# Video Products Technical Bulletin 30-2005-034

SUBJECT: REUSE PARTS WHEN REPLACING THE A BOARD

MODEL: **PVM-1340/M**  
**PVM-1341**  
**PVM-1342Q**  
**PVM-1343MD**  
*PVM-1440QM*  
*PVM-1442QM*  
*PVM-1443MD*  
*PVM-1444QM*

Figure 1

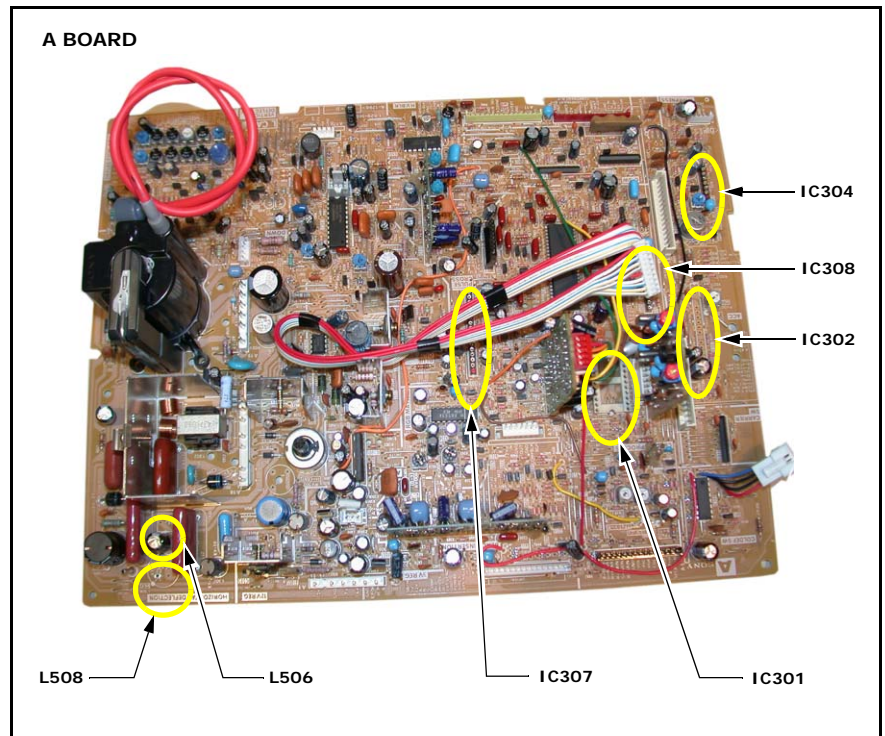
When you replace the A board (A-1296-520-D), remove the parts in Table 1 from the former board and install them on the new board.

The new A board does not contain the parts, and the parts are no longer available. (See Figure 1.)
